UNITED STATES PATENT AND TRADEMARK OFFICE

APPLICATION NO.	FILING DATE	FIRST NAMED INVENTOR	ATTORNEY DOCKET NO.	CONFIRMATION NO.
10/790,524	03/01/2004	Douglas P. Gethmann	06005/39970	2733
4743 7590 07/24/2007 MARSHALL, GERSTEIN & BORUN LLP 233 S. WACKER DRIVE, SUITE 6300 SEARS TOWER CHICAGO, IL 60606			EXAMINER GARCIA, ERNESTO	
			ART UNIT 3679	PAPER NUMBER
			MAIL DATE 07/24/2007	DELIVERY MODE PAPER

<p align="center">Office Action Summary</p>	<p>Application No.</p> <p>10/790,524</p>	<p>Applicant(s)</p> <p>GETHMANN, DOUGLAS P.</p>	
	<p>Examiner</p> <p>Ernesto Garcia</p>	<p>Art Unit</p> <p>3679</p>

DETAILED ACTION

Warren, 335,259

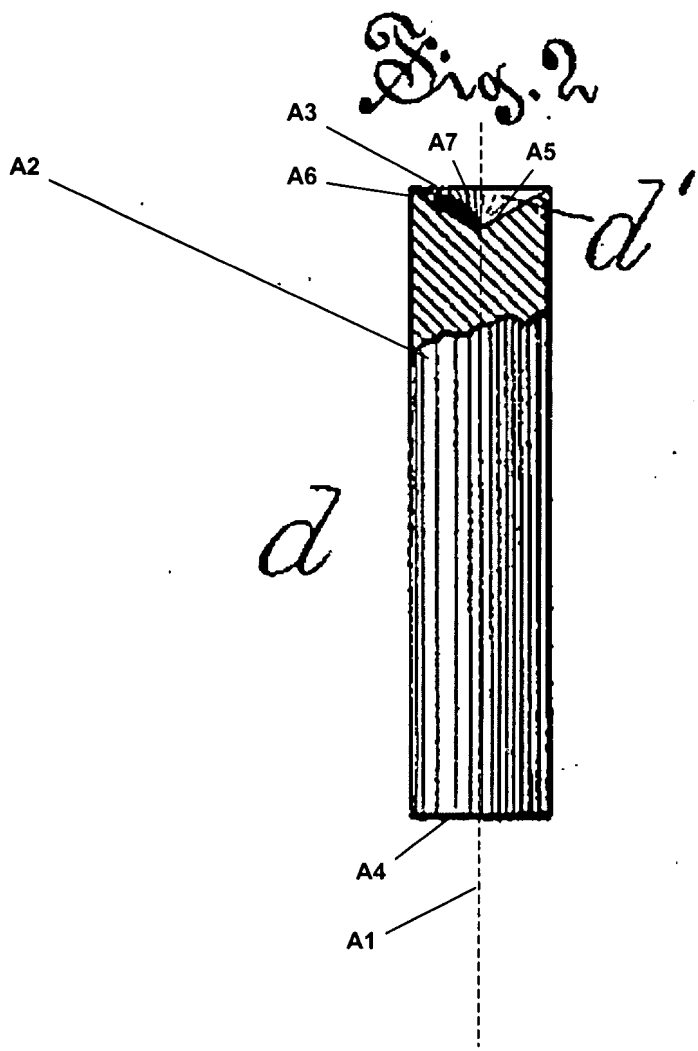
Regarding claim 24, Warren discloses, in Figures 1 and 2, a locking mechanism comprising a valve stem extension **a** and a generally cylindrical body **d**. The extension **a** has a tip **c** and a male thread **b**. The cylindrical body **d** has a longitudinal axis **A1** (see marked-up attachment). The body **d** includes a non-threaded outer side surface **A2**, a first axial end **A3**, and a second axial end **A4**. A wedge **d'** is formed adjacent the first axial end **A3**. The wedge **d'** includes an inner engagement surface **A5**. The wedge **d'** further includes a non-threaded outer engagement surface **A6**. The wedge **d'** is sufficiently pliant.

Regarding claim 2, the wedge **d'** forms a continuous rim extending around the first axial end. The rim **2** has a triangular cross-section.

Regarding claim 3, a central portion of the first axial end **A3** defines a cavity **A7** that forms the inner engagement surface **A5**.

Regarding claim 4, the cavity **A7** has a cone shape.

Regarding claim 5, the cone shape has a vertex angle of approximately 120 degrees.

Regarding claim 6, the wedge **d'** is able to deform radially outward as an insertion force is applied to stem extension **a**.

Regarding claim 7, the body and the stem extension are formed of a similar material (note that the cross hatching is metal for the components).

Schobbe, 4,498,680

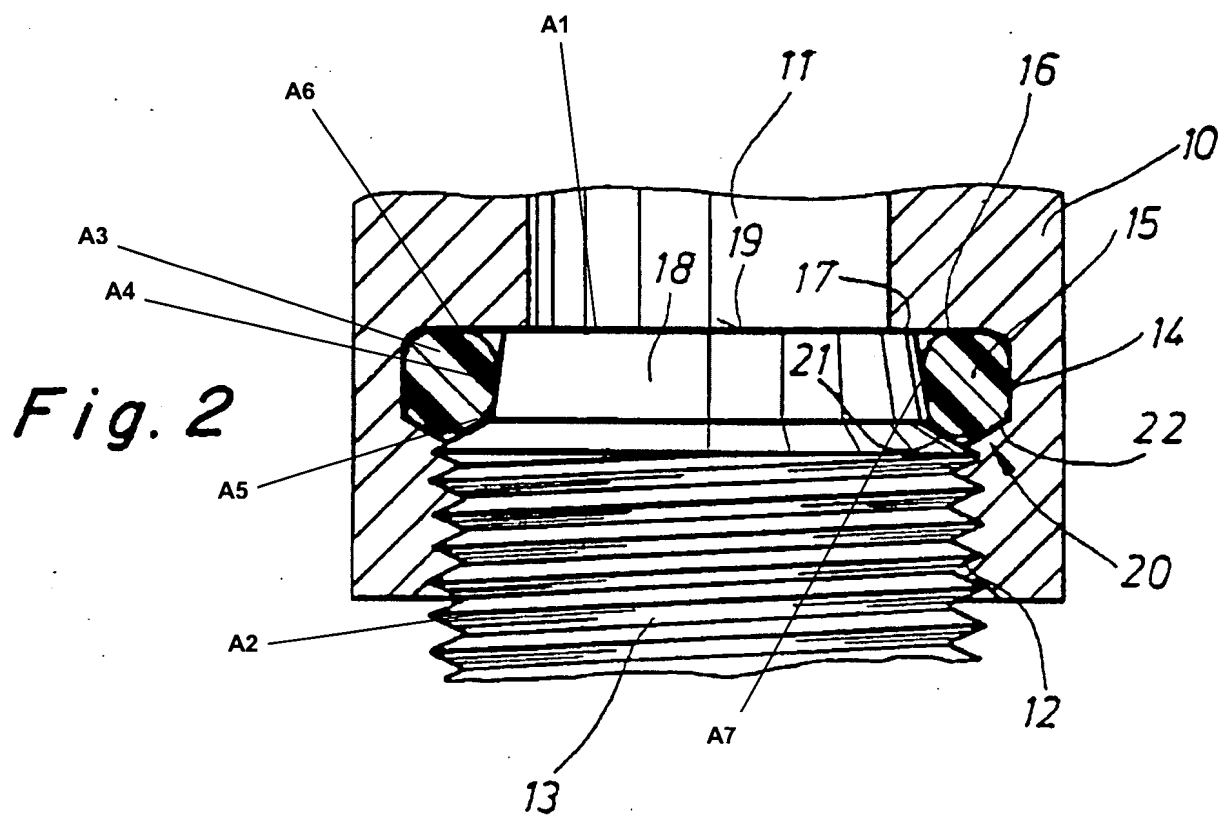
Regarding claim 9, Schobbe discloses, in Figure 2, a locking assembly comprising a first connection member **13**, a second connection member **10**, and a locking mechanism **15**. The first connection member **13** defines an insertion end **A1** (see marked-up attachment) formed with a male thread **A2**. The second connection member **10** defines an aperture **11** formed with a female thread **12** complementary to the male thread **A2**. The locking mechanism **15** comprises a body **A3** and a continuous wedge **A4**. The body **A3** extends along an axis and has an outer side surface **14**. The body **15** defines a first axial end **A5** and a second axial end **A6**. The wedge **A4** projects

from the first axial end **A5**. The wedge **A4** has an inner engagement surface **A7** and a substantially non-threaded outer engagement surface. The inner engagement surface **A7** engages the insertion end **A1** of the first connection member **13**. The wedge **A4** is sufficiently pliant.

Regarding claim 11, the wedge **A4** forms a continuous rim extending around the first axial end **A5**.

Regarding claim 12, a central portion of the first axial end **A5** defines a cavity (the opening) that forms the inner engagement surface **15**.
